TRAFFIC IMPACT ANALYSIS

RENFROW SITE

Monroe Road (SR 1009) Between Galleria Boulevard & Gander Cove Lane
Matthews, North Carolina

January 2017

**SUGGESTED
LANEAGE**

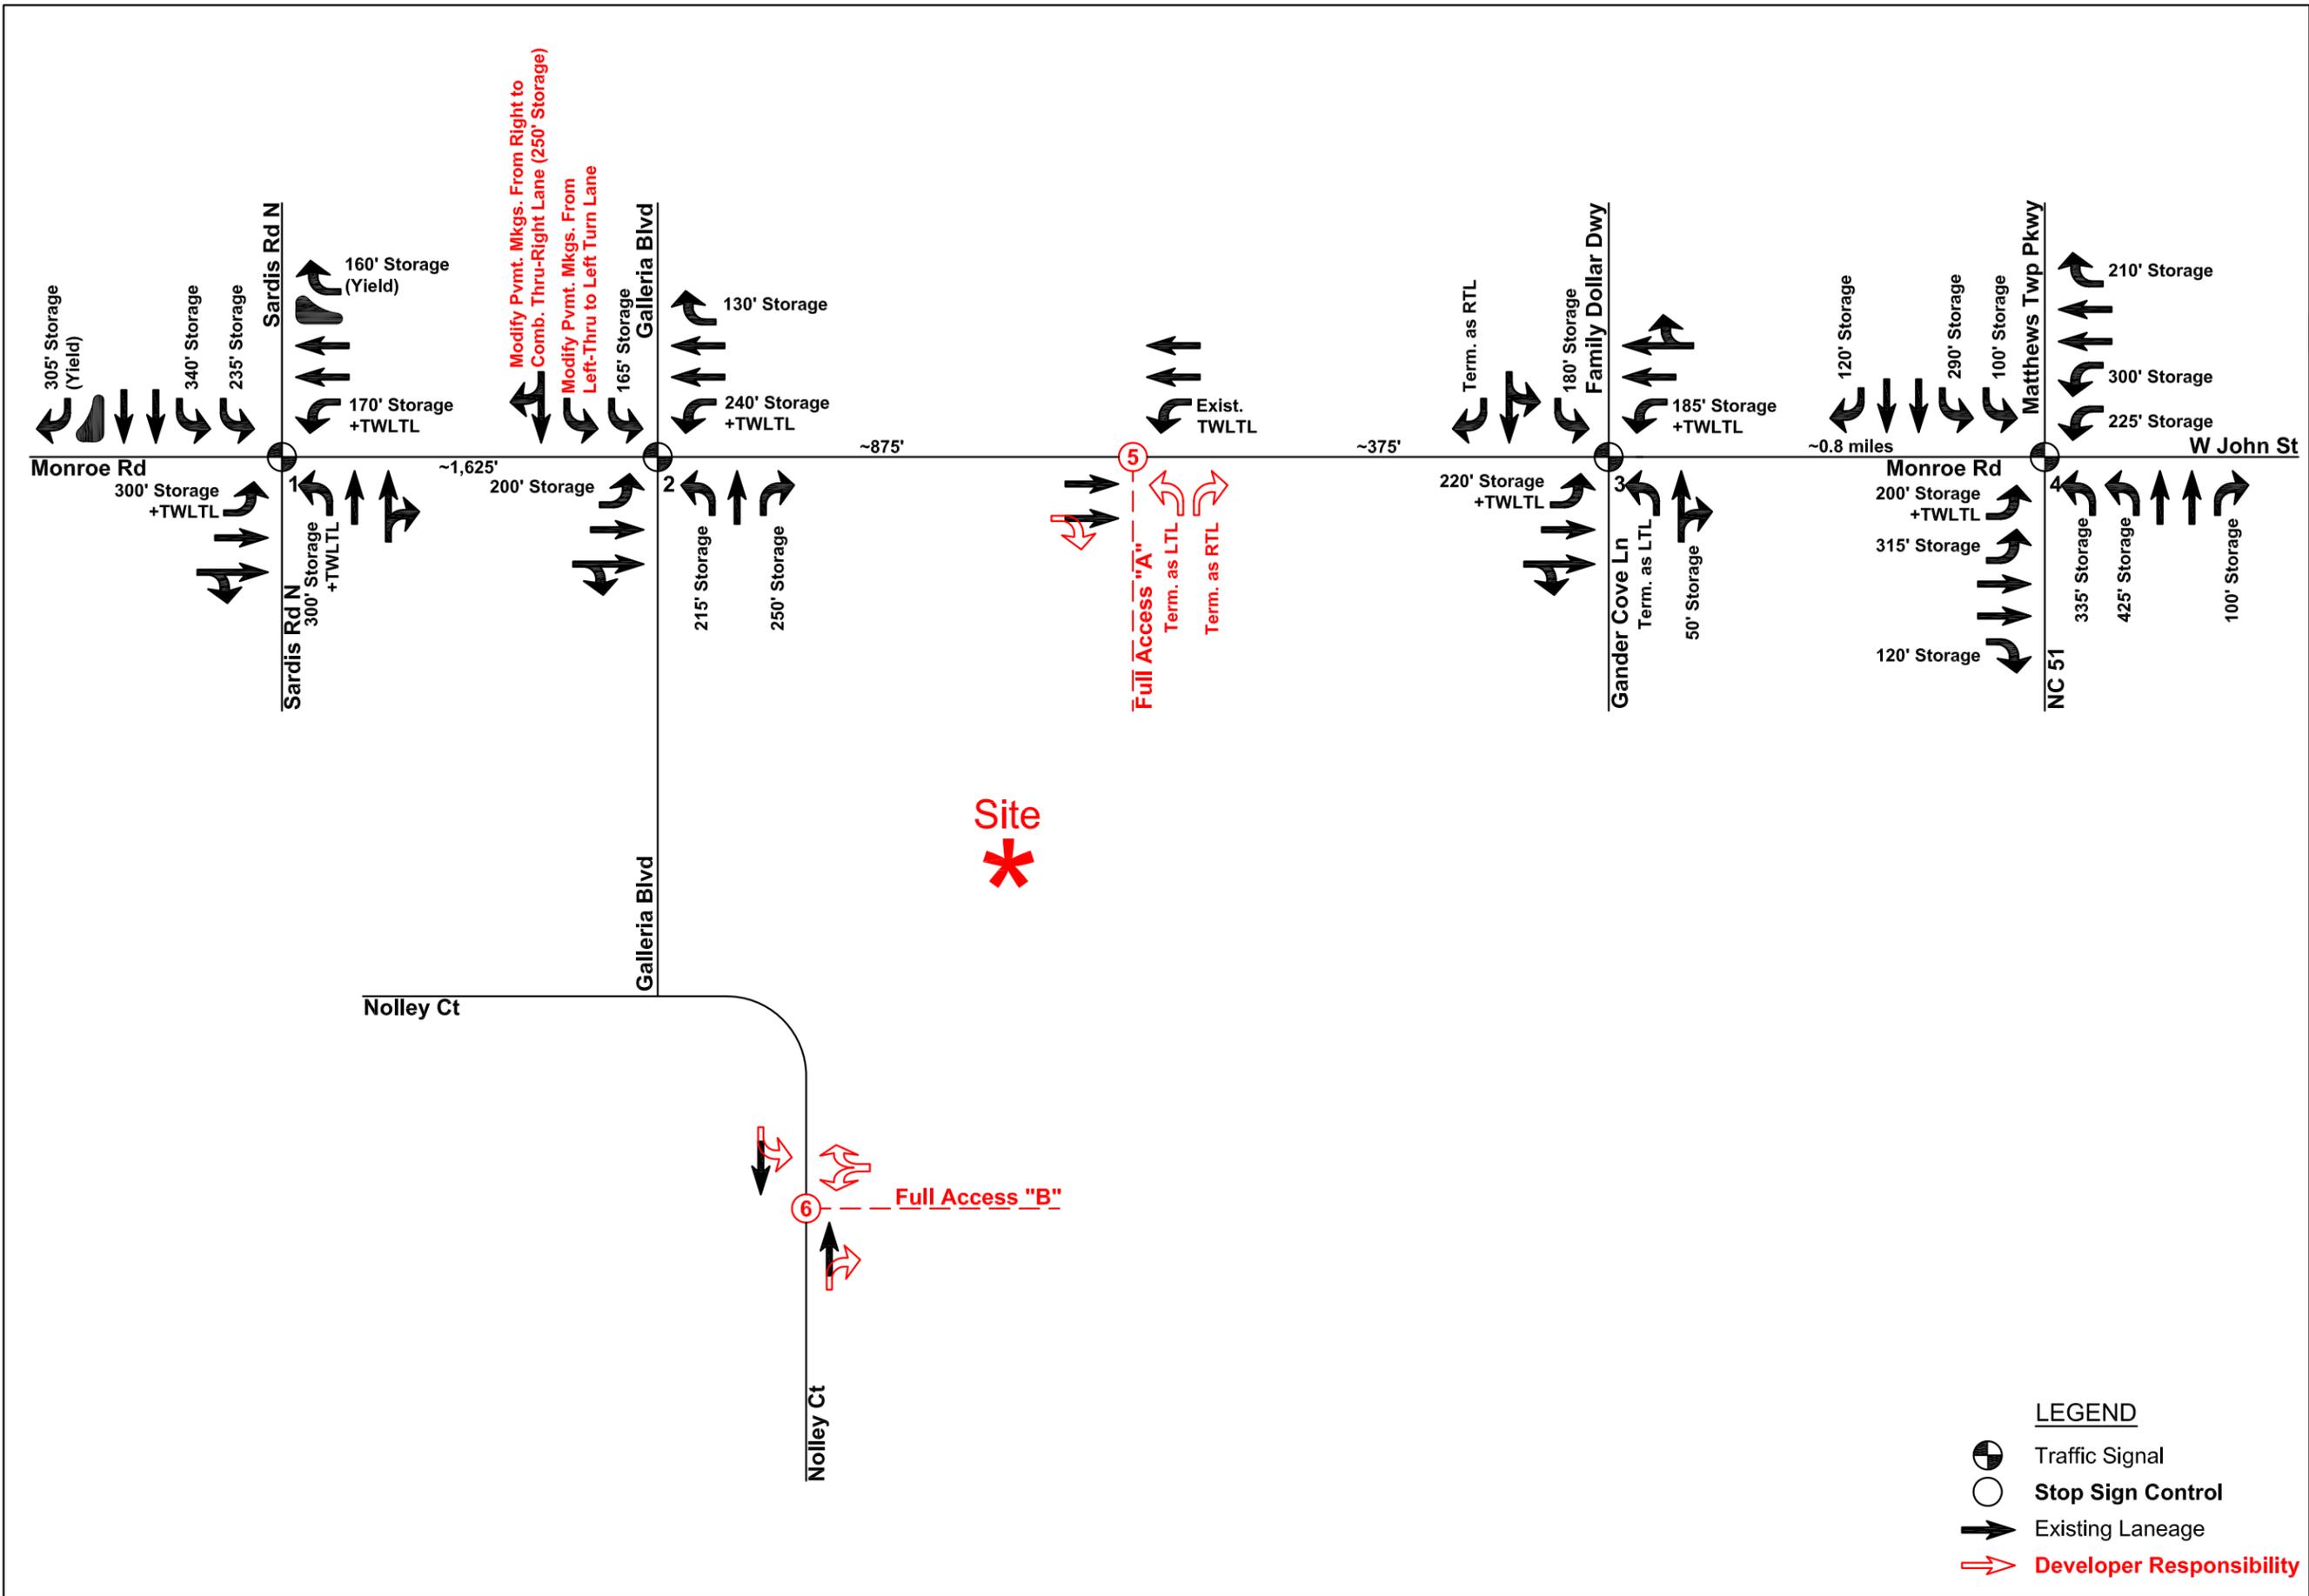
REVISIONS:
1, 01/04/17 Imps, per NCDOT comments on DRAFT TIA

In looking over this TIA I realized it was the same site as the Matthew Galleria TIA submitted by DRG in 2014. A couple of the differences though are the amount of development and number of access drives being requested on Monroe Rd. The previous site had only one access connection to Monroe Rd where this new site has two. We are not agreeable to allowing 2 access drives to Monroe Rd. The RI/RO access point will need to be removed from the site plan. The last TIA you did for this parcel had a recommendation for an eastbound right turn lane on Monroe Rd at Galleria. This new TIA has dropped this as a recommended mitigation. While we are OK with that we do feel that some changes are needed to the Monroe Rd and Galleria Rd signal. We are asking that this developer modify the signal and southbound approach from a left only, thru/left and right only lane to a left only, left only and thru right lane. This will allow the signal to become unsplit phased and increase the efficiency of the signal and overall reduce delay at the intersection.

Your request for signal and southbound approach modifications are reasonable and I understand the access revision and will pass this along to the developer.
